# PLAN COMMISSION

**March 19, 2015**

Assign two Commissioners to  
meet with the Applicant in a  
work session.

## DAVITA DIALYSIS 16767 S. 80<sup>TH</sup> AVENUE

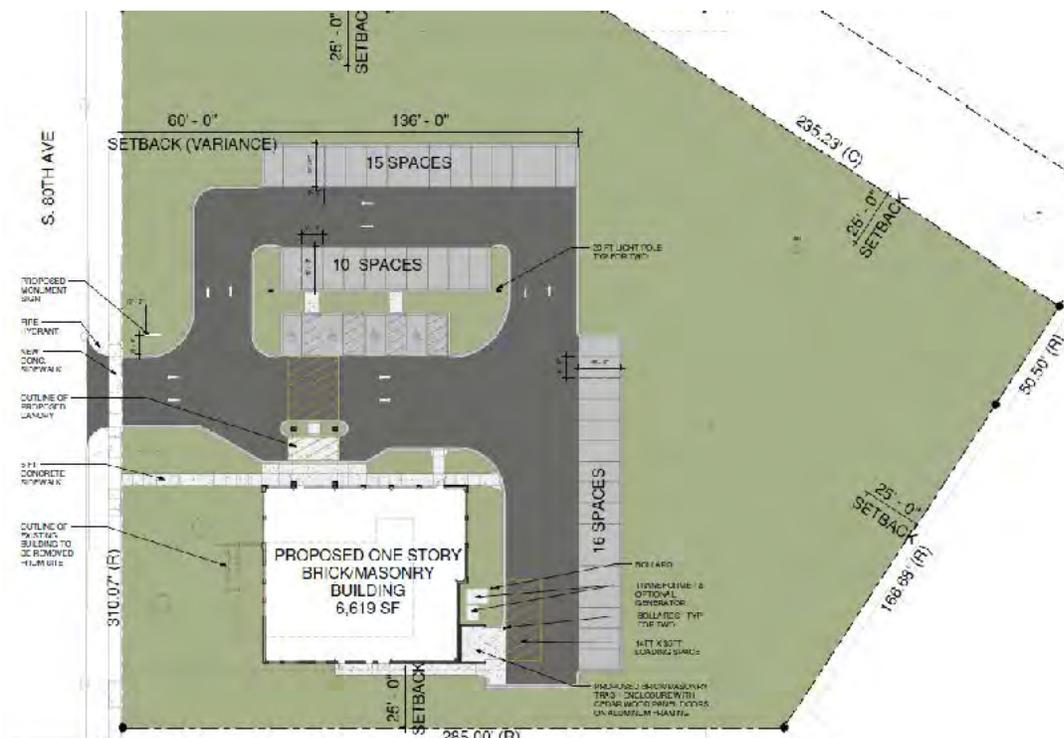
The B-1 District requires a 125' front yard; the proposed site plan indicates a 60' front yard setback. As part of the analysis for the variance request, staff reviewed the property in context with the surrounding area in an effort to align the property with existing patterns of development. Although the property does not fall within the Urban Design Overlay District, it is located relatively close to the District, therefore, staff also reviewed the proposal using the Overlay district design standards, (Section V. D.2.

of Village Zoning Ordinance) keeping in mind site design and architectural guidelines. The commercial uses across the street reflect similar front yard setbacks (50-60') to the existing Eiche Turner building (50') and the proposed setback for DaVita (60'). The retail center to the north of the subject property is also less than the ordinance requirement of 125' measuring at approximately 80'. The Applicant has cooperated with Staff in aligning their project with these principals and locating the parking field to the side and rear of the building and decreasing the front yard setback. In doing so the building has been proposed with a 60' front yard setback which will require a variation.

Two other variations will also be required; lot area and lot width minimums cannot be met with the existing parcel. According to the best information available, the Eiche Turner building was built in 1983. Per the Comprehensive Rezoning of 1978, which amended the Zoning Ordinance of 1956, the B-1 Zoning District requires a 4 acre lot minimum and a 600' lot width. Staff could not locate evidence of a variance approving lot width and lot area variations when the Eiche Turner building was constructed.. Staff is assuming that the B-1 District was assigned to these properties for the purpose of controlling uses rather than for enforcement of bulk regulations. Therefore, with the re-subdivision of the two lots it is appropriate to consider lot area and lot width variations to provide for their legal non-conforming status.

## LANDSCAPE PLAN

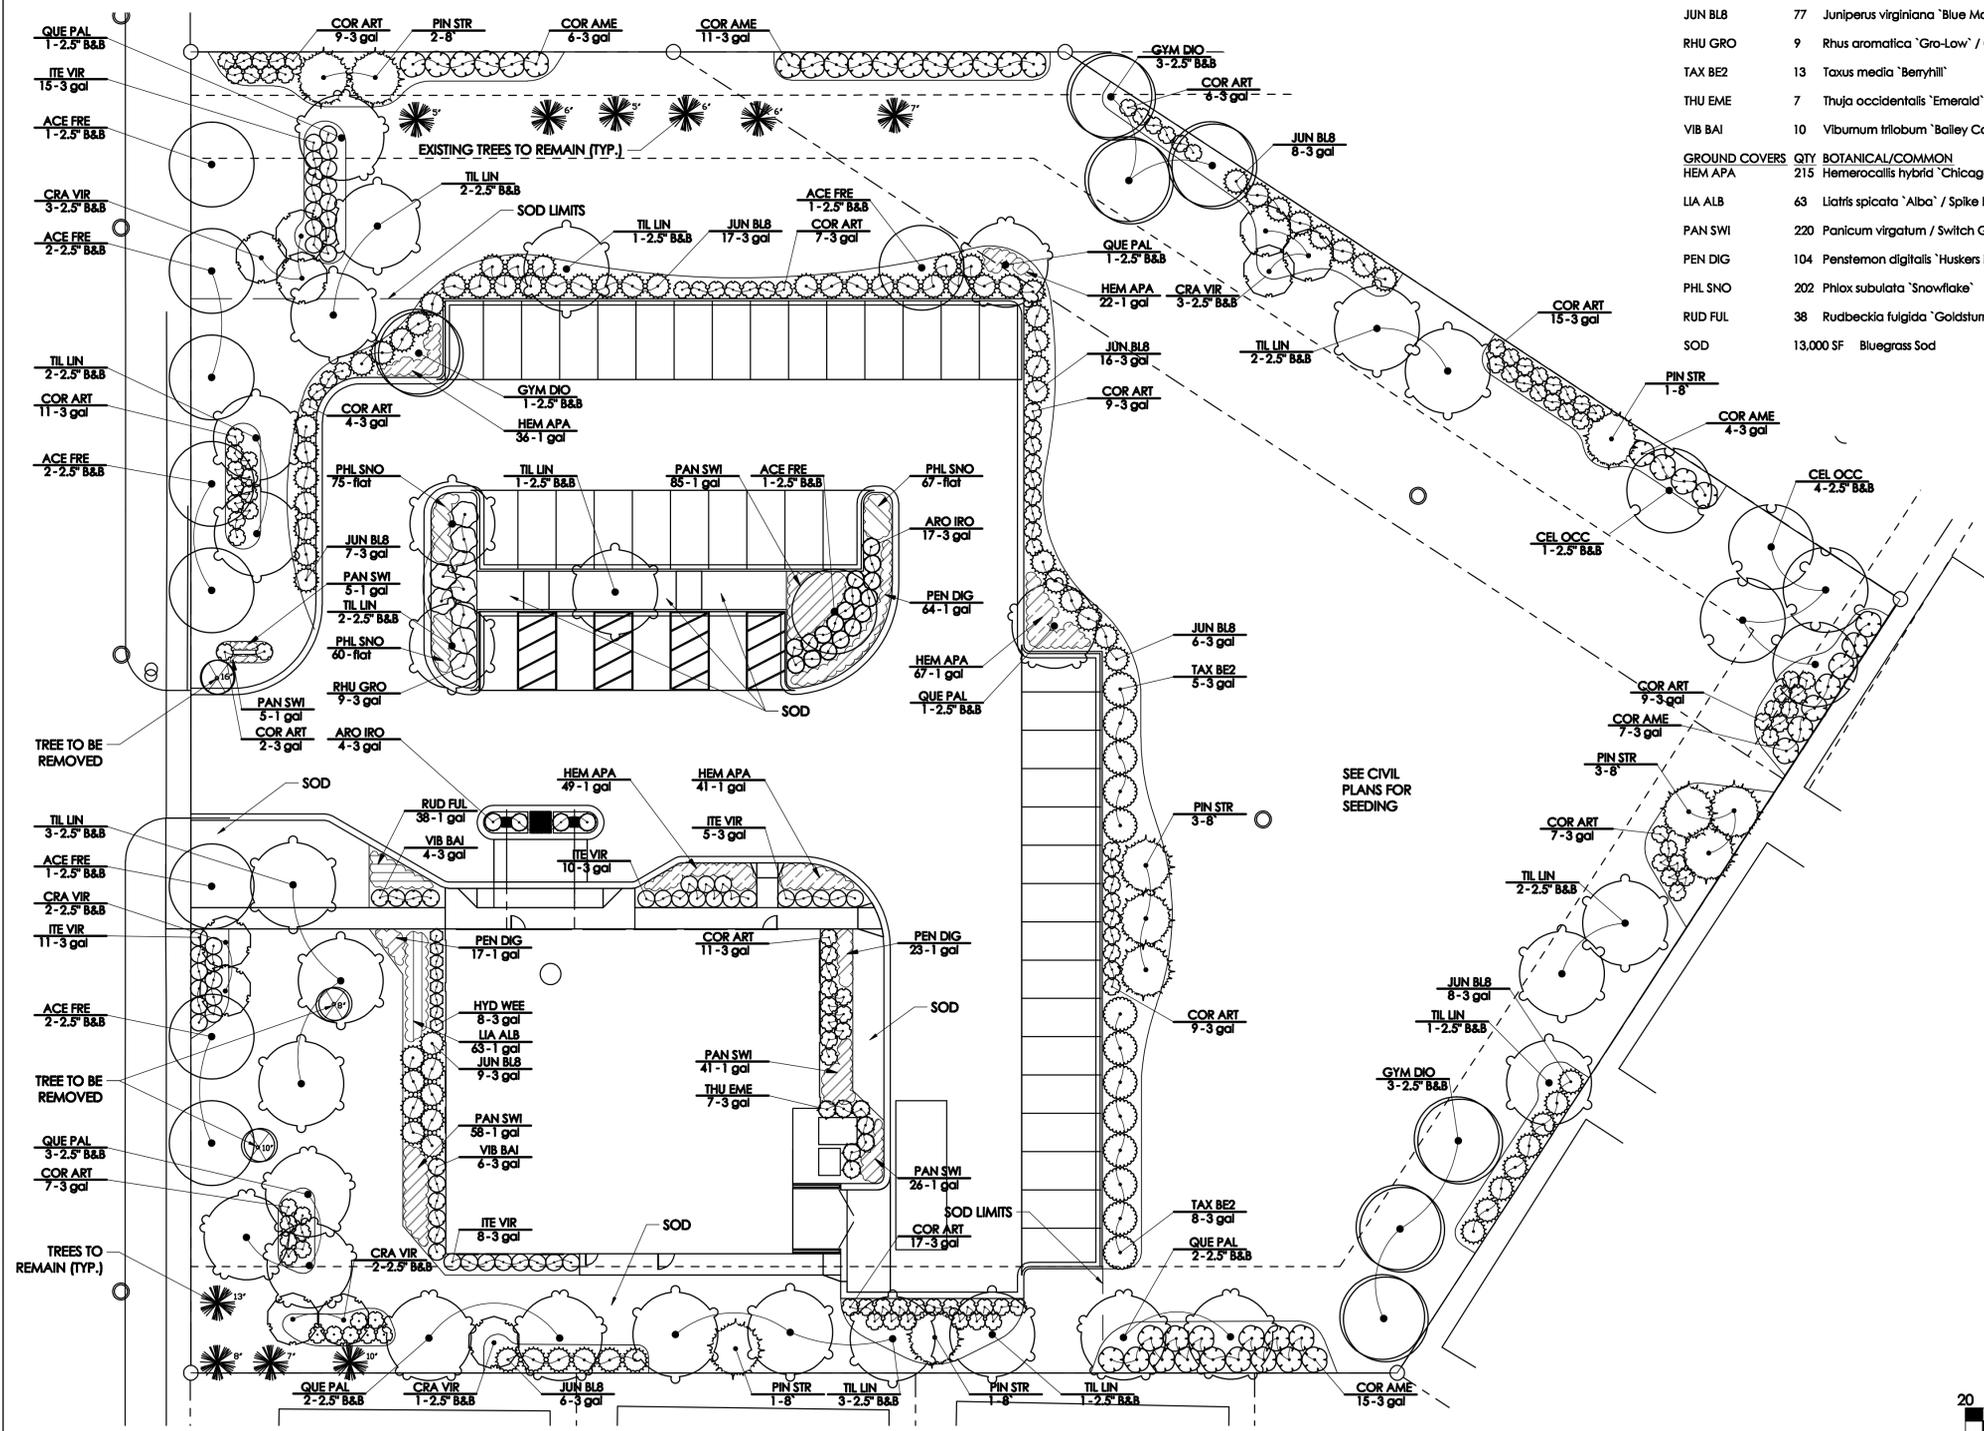
A cross-access easement will be recorded with the plat to provide future cross-access if the property to the north redevelops. Staff recommends relocating any proposed landscaping out of the cross-access easement.

**Open Item #1: Proposed landscape conflicts with cross access easement.**

In addition to bufferyard requirements, the Site Plan must meet screening requirements for the parking areas. Parking areas are required to be “*screened from the view of adjacent properties and streets by evergreen planting that will attain a height of three (3) feet within three (3) years*”. The Applicant has revised their plans to provide additional screening along the perimeter of the parking lot, which includes a fair amount of evergreen material. Some deciduous trees have also been provided in the parking lot to provide some shade to the parking lot. Staff recommends relocating some of the trees that are shown in the cross-access easement area into the parking lot interior to provide additional shade. Staff also recommends providing a few more evergreen trees to balance the front façade and provide some year round screening in the parking lot.

**Open Item #2: Lack of shade and evergreen trees in parking lot.**

The Landscape Plan indicates some areas where it appears the shrubs are located too far apart to create an adequate screen. The landscape architect has requested that shrub spacing be indicated on the plan.

**Open Item #3: Shrub spacing is not indicated on the plan.**

<i>Open Items</i>	<i>Suggested Resolutions</i>
1	<i>Proposed landscape conflicts with cross-access easement.</i>	<i>Remove proposed landscape from cross-access easement.</i>
2	<i>Lack of shade and evergreen trees in parking lot.</i>	<i>Provide additional plant material as recommended by Staff.</i>
3	<i>Shrub spacing is not indicated on the plan.</i>	<i>Provide shrub spacing on plan.</i>
4	<i>The north façade provides awnings over two (2) windows, which appears inconsistent with the overall design.</i>	<i>Add two (2) additional awnings on north façade.</i>

1 NORTH ELEVATION - BRICK FACE PERCENTAGE  
1/8" = 1'-0"

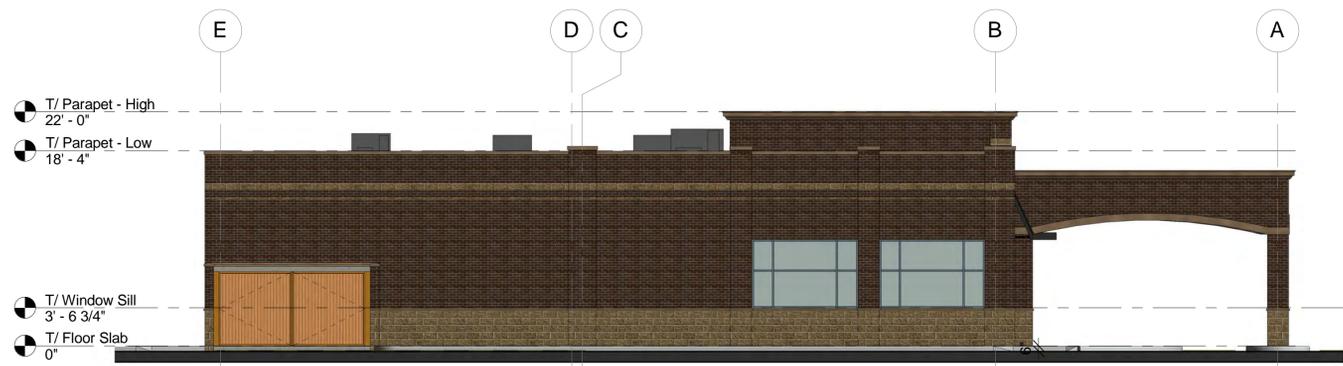
Staff has expressed concern regarding the lack of awnings over all the windows on the north façade. The Applicant provided awnings only over two (2) of the four (4) windows east of the port-cochere; Staff recommends providing awnings over all the windows for a more complete look to the façade.

***Open Item # 4: The north façade provides awning over two (2) windows, which appears inconsistent with the overall design.***

**1 SITE LIGHTING PLAN**  
1" = 20'-0"

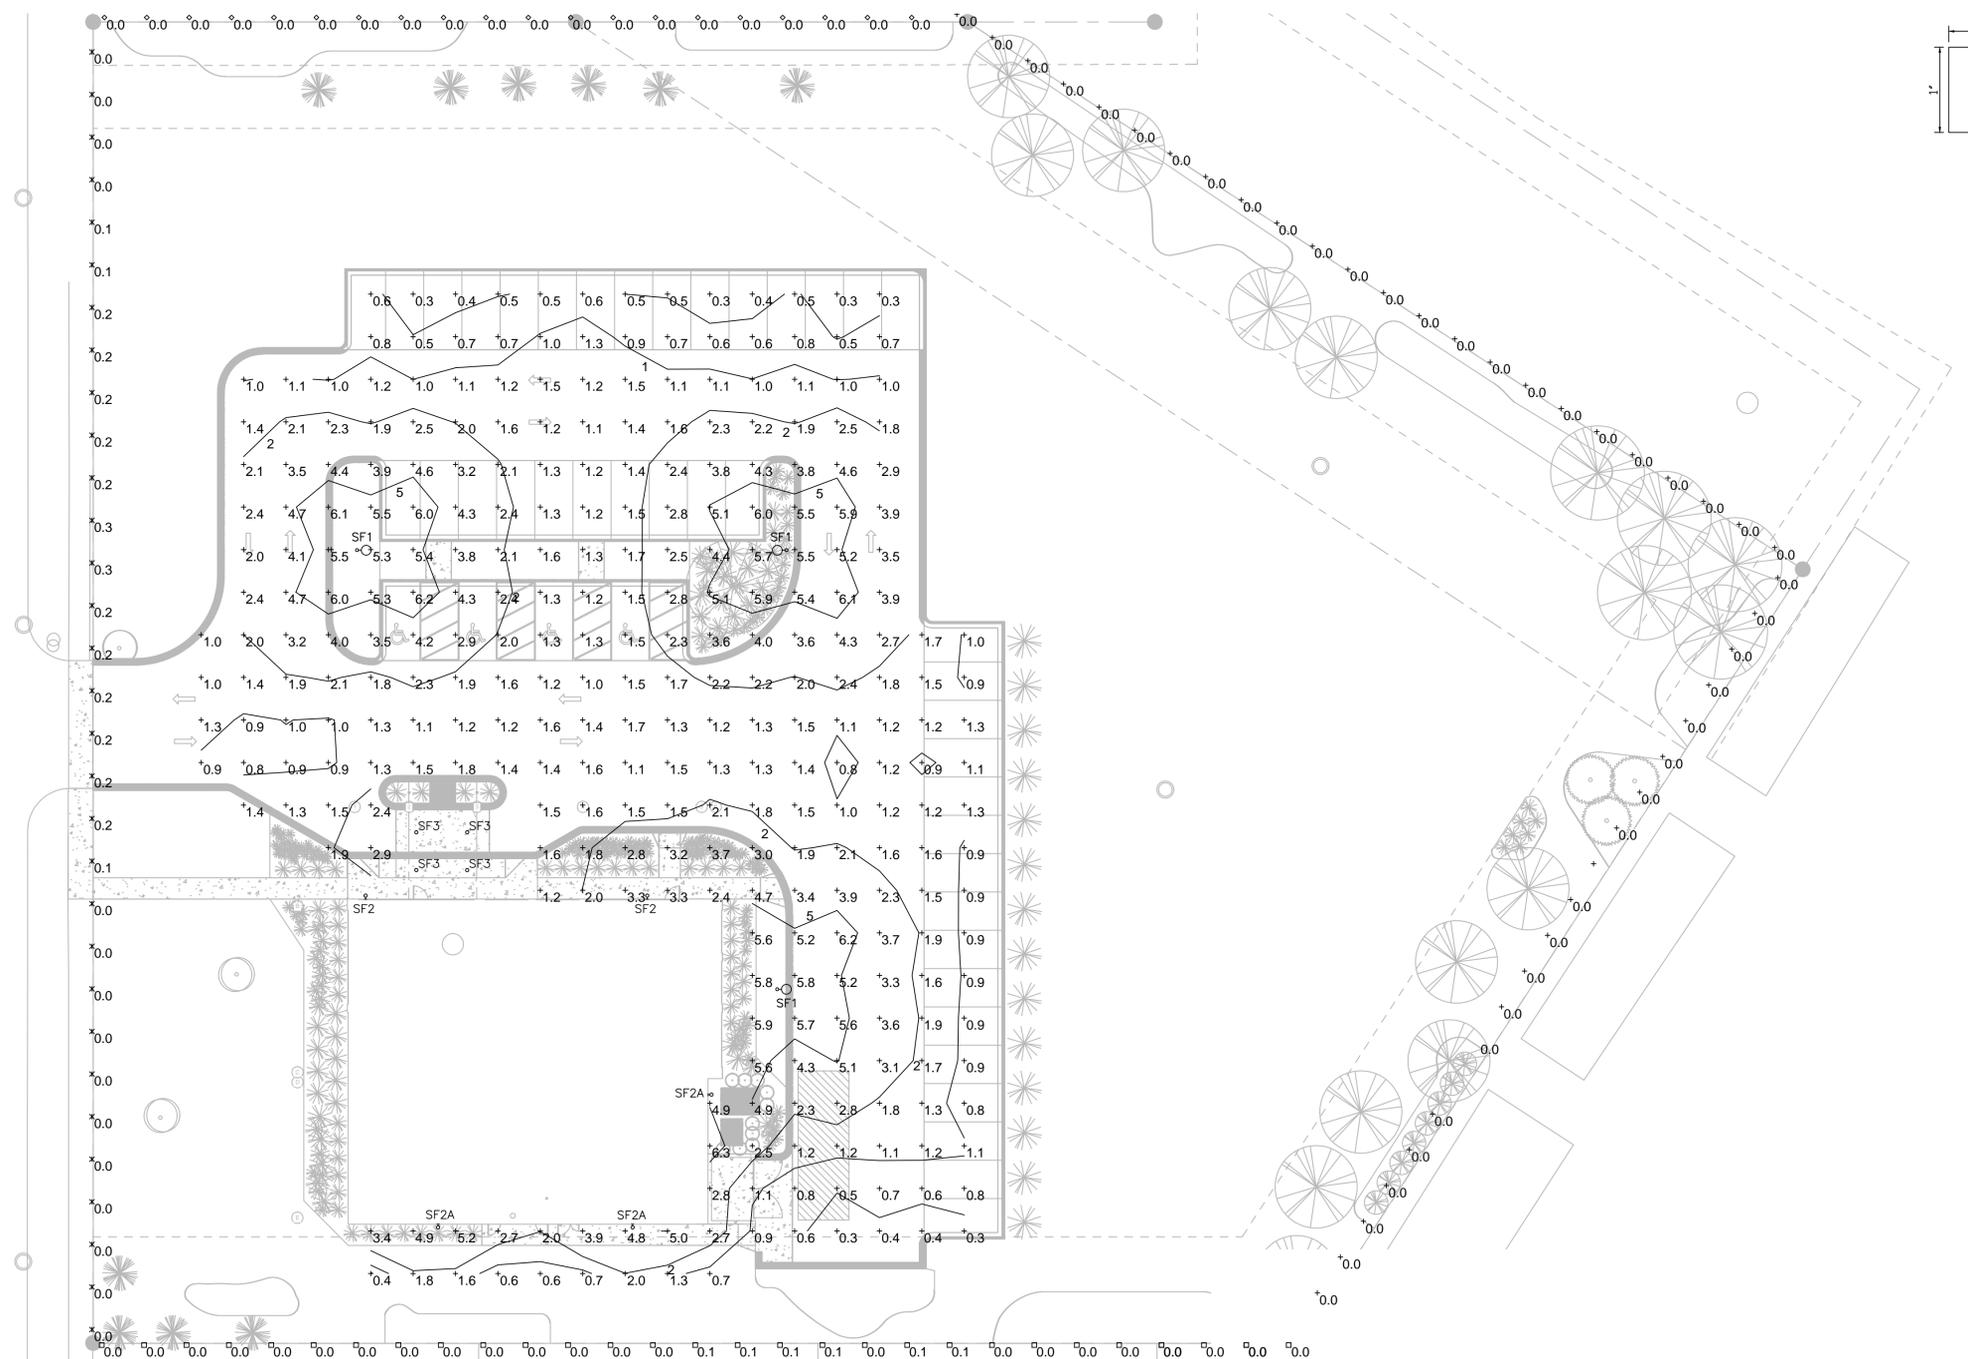
The Zoning Ordinance limits the light shed from outdoor lighting to no greater than .5 foot candles at the property line. Off-site glare must also be eliminated. The proposed photometric plans conform to Village requirements and have readings of .1 foot candles or less along those property lines adjacent to residential uses, and readings of .3 or less along 80<sup>th</sup> Avenue.

The parking lot will have three lights as indicated in the adjacent diagram (indicated by red stars). These lights are metal halide, with full cutoff, and are 20’ in height. The blue stars indicate wall sconces, and the green stars are recessed lighting in the porte-cochere.
